# APPLICATION

## SEWAGE DISPOSAL TESTING

STATE OF MARYLAND - DEPARTMENT OF HEALTH AND MENTAL HYGIENE

PERCOLATION CERTIFICATION PLAN &  
REVISED BP SITE PLAN PC # A514268  
**FARSIDE LOT 63**  
TAX MAP 23 BLOCK 21 3RD ELECTION DISTRICT  
PARCEL '126' HOWARD COUNTY, MARYLAND

Lot 25  
New  
revised Plat  
07 = OLD  
TEST  
PITS

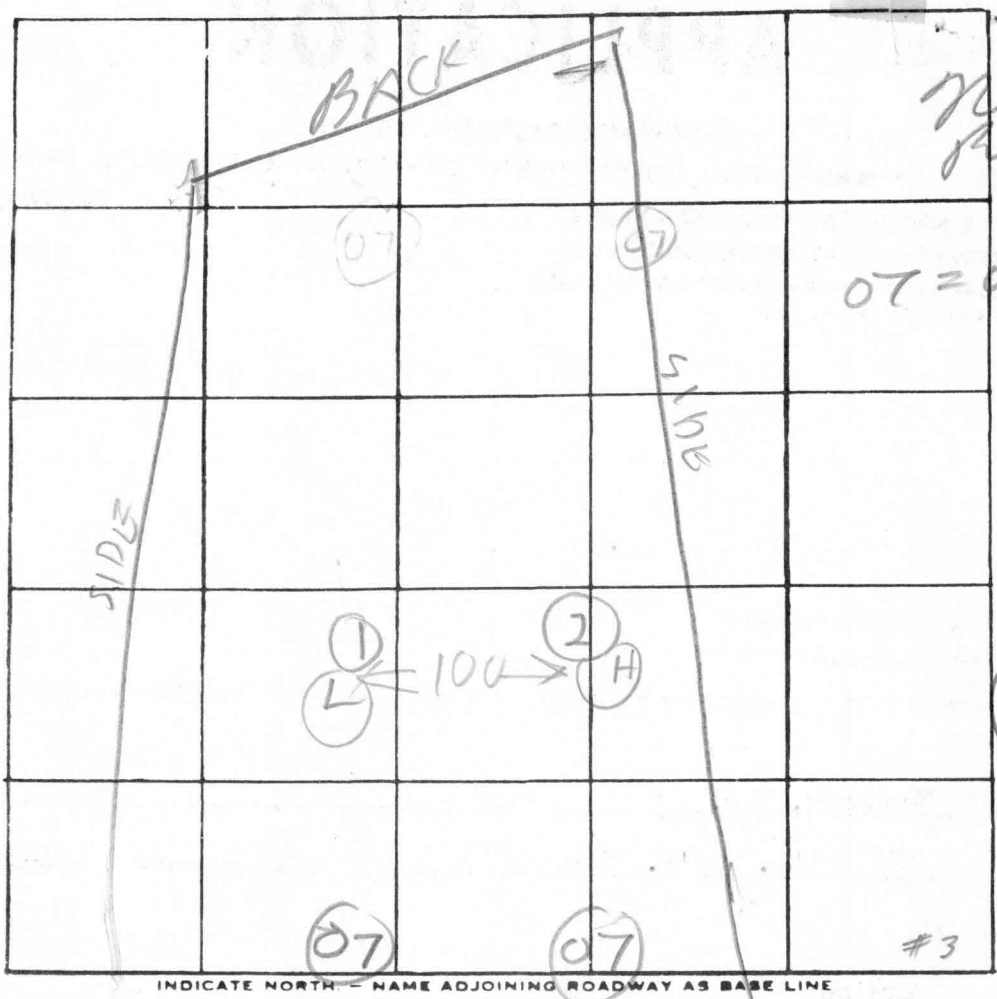
REASONS FOR REJECTION OR HOLDING 7/14/78 test # 3 and # 4 combined per

2 minutes  
avg  
Only 4'  
Need to  
see hole  
location  
as to  
which to  
use.

Final test OK 10/25/79

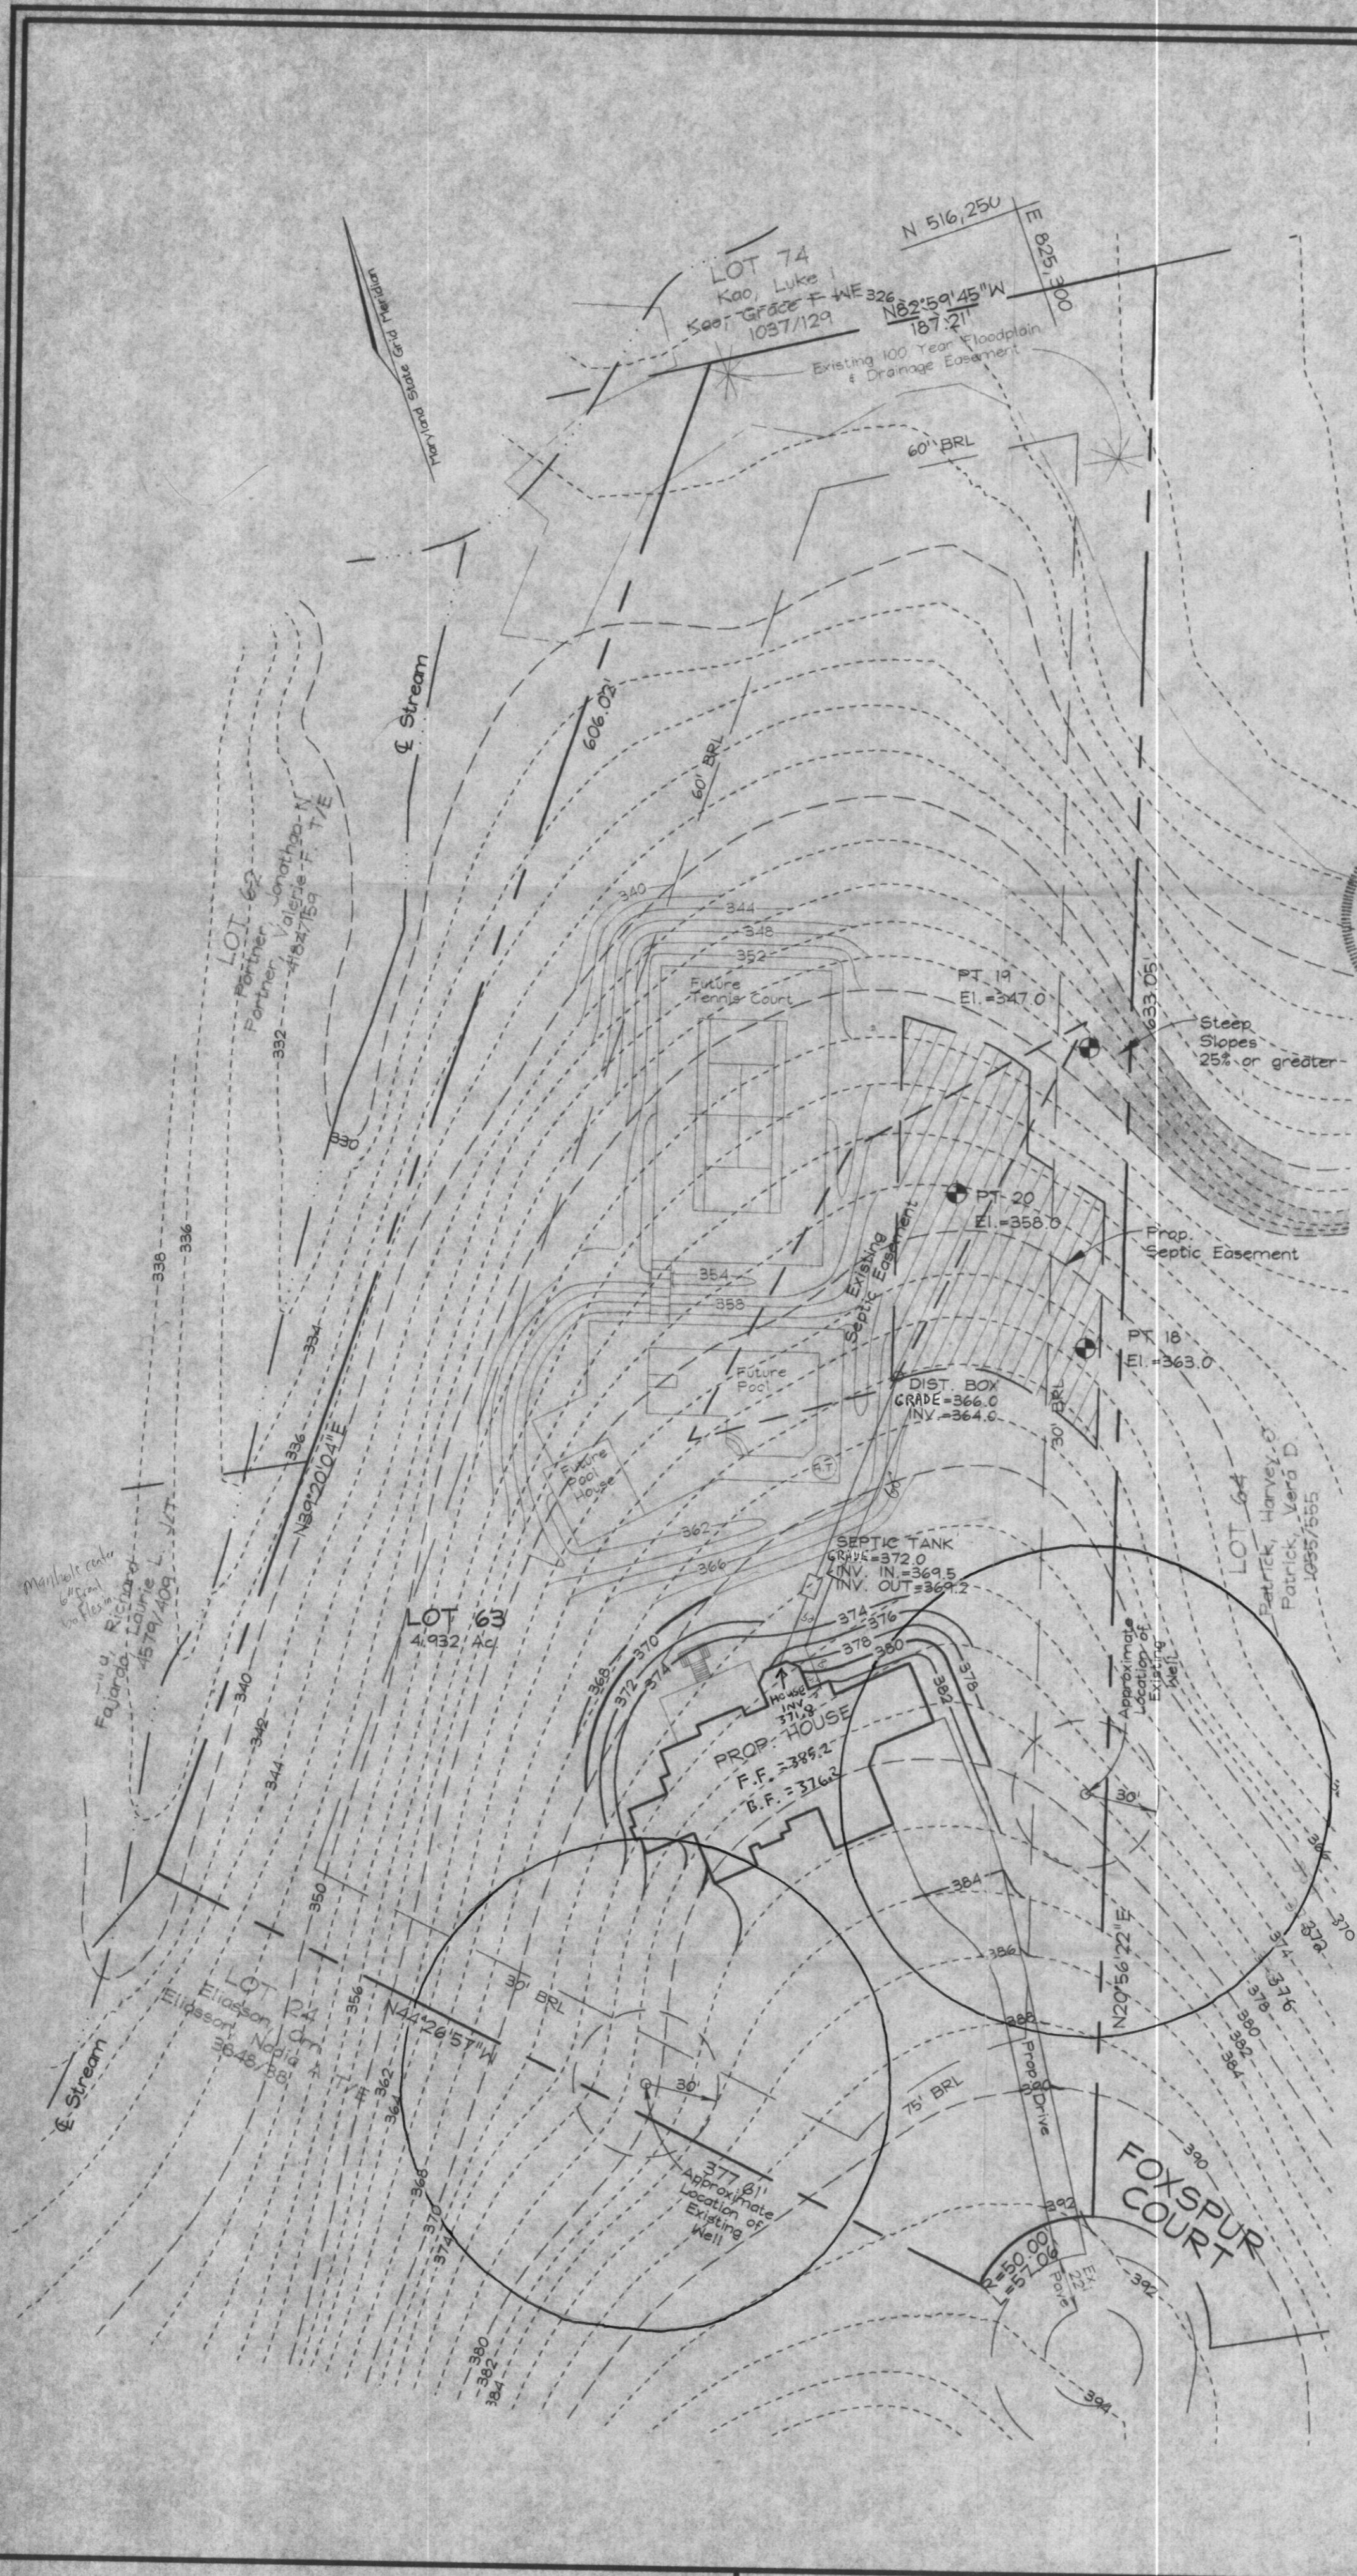
\* 8. Signature of this document by the Health Department does not indicate approval of the proposed grading between the approved (revised) sewage easement and the proposed pool and tennis court. A distance of 20' should be maintained between the grading and the approved sewage easement. In addition, the proposed grading over the proposed pipe from the septic tank to the distribution box or the proposed location of this pipe will have to be adjusted during installation so as not to be in conflict.
